**DOCUMENT 00 90 00  
ADDENDUM**

**ADDENDUM NO. [2]                      Date: November 8, 2018**

**RE:                      GLENWOOD COMMUNITY SCHOOL DISTRICT  
ATHLETIC COMPLEX IMPROVEMENTS BID PACKAGE 2 REBID  
400 SIVERS ROAD  
GLENWOOD, IOWA 51534  
HSR PROJECT NO. 18005**

**A101R**

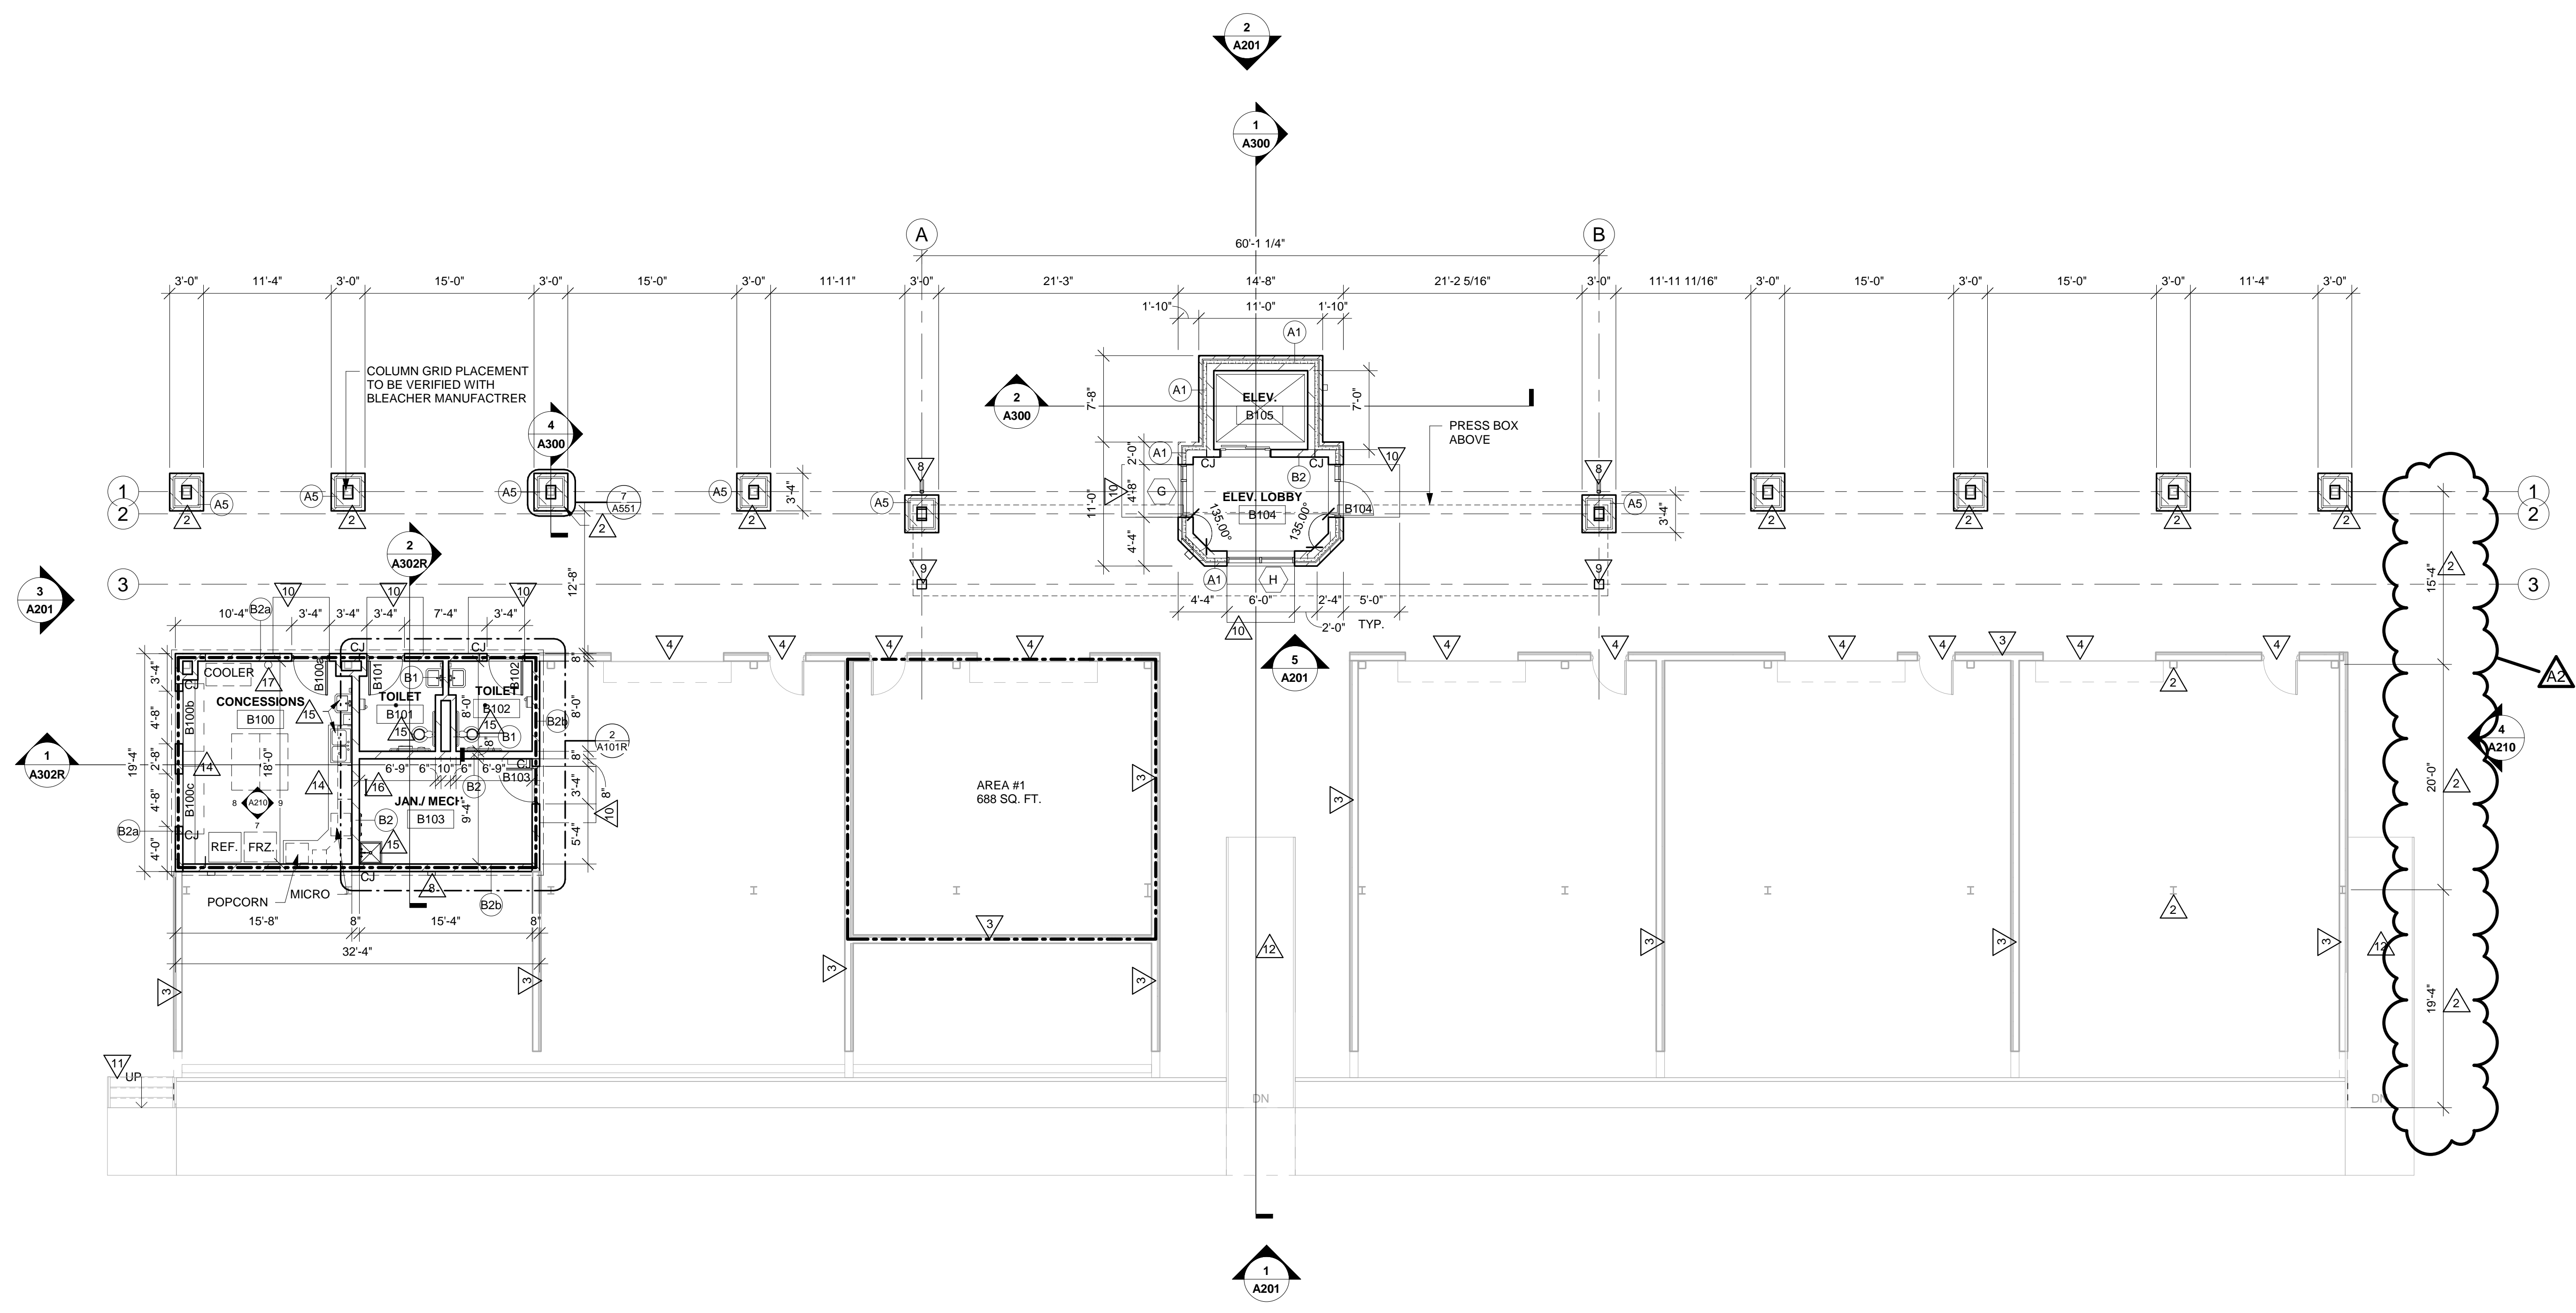
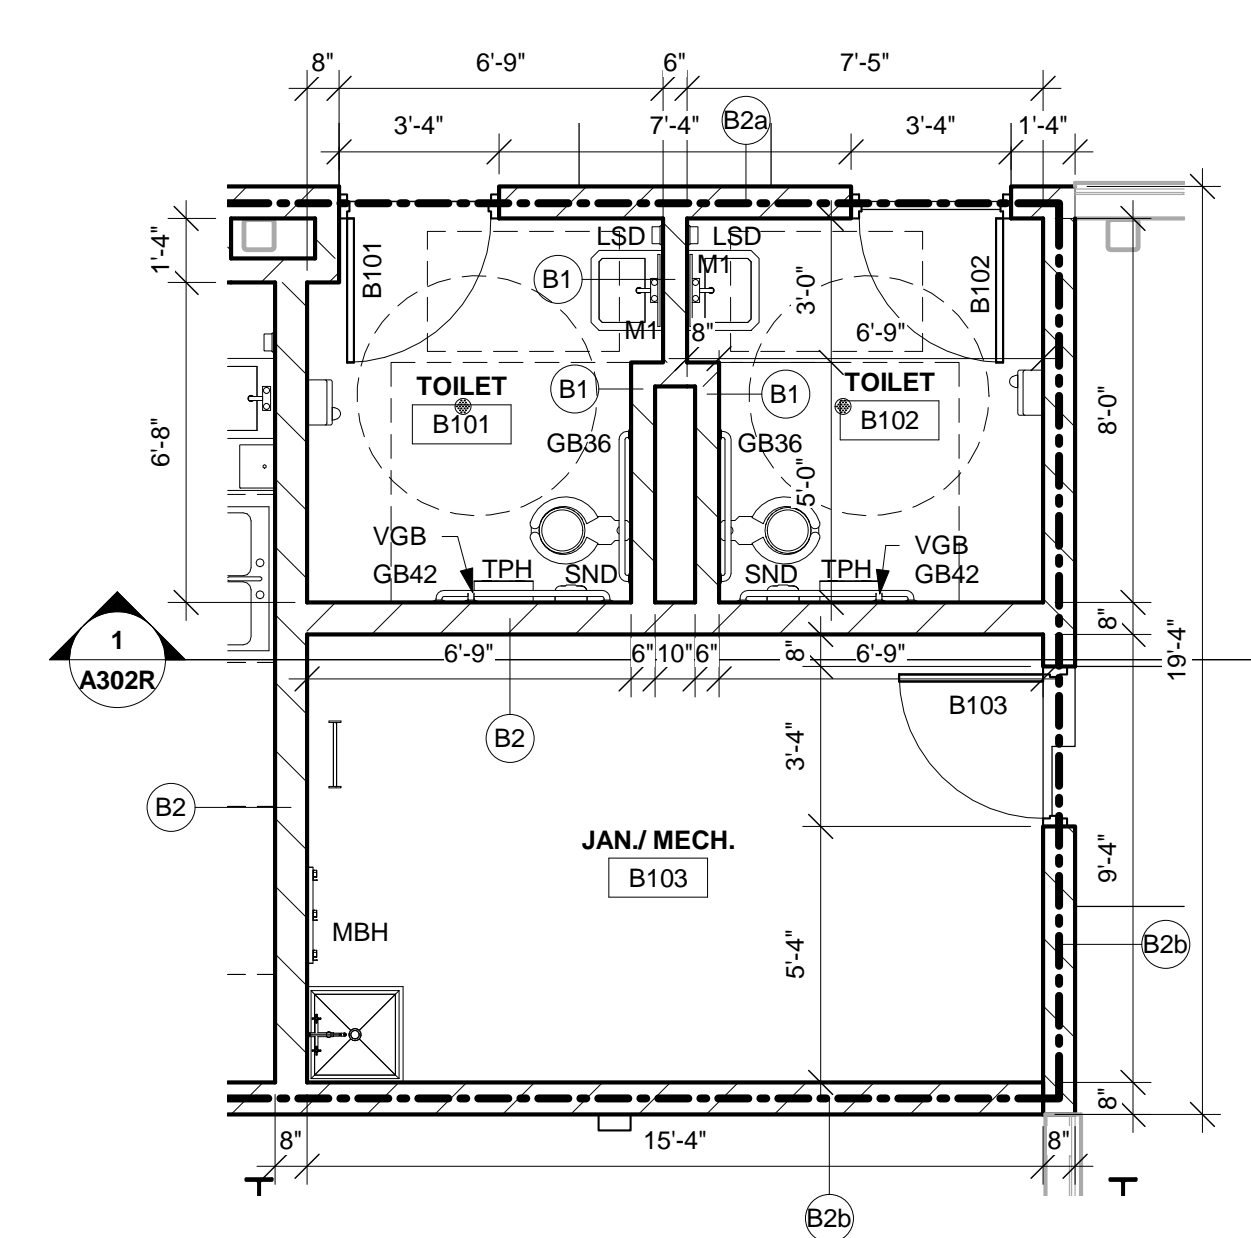
5. Sheet A101R FIRST FLOOR STADIUM PLAN 30 x 42 Drawing attached hereto
  - a. Revisions clouded on Drawing.
6. Sheet A302R FIRST FLOOR STADIUM BUILDING SECTIONS 30 x 42 Drawing attached hereto
  - a. Revisions clouded on Drawing.
7. Sheet P104R PLUMBING AND GAS RISERS 30 x 42 Drawing attached hereto
  - a. Revisions clouded on Drawing.
8. Sheet E101R FIRST FLOOR STADIUM LIGHTING PLAN 30 x 42 Drawing attached hereto
  - a. Revisions clouded on Drawing.
9. Sheet E102R SECOND FLOOR PRESS BOX LIGHTING PLAN 30 x 42 Drawing attached hereto
  - a. Revisions clouded on Drawing.
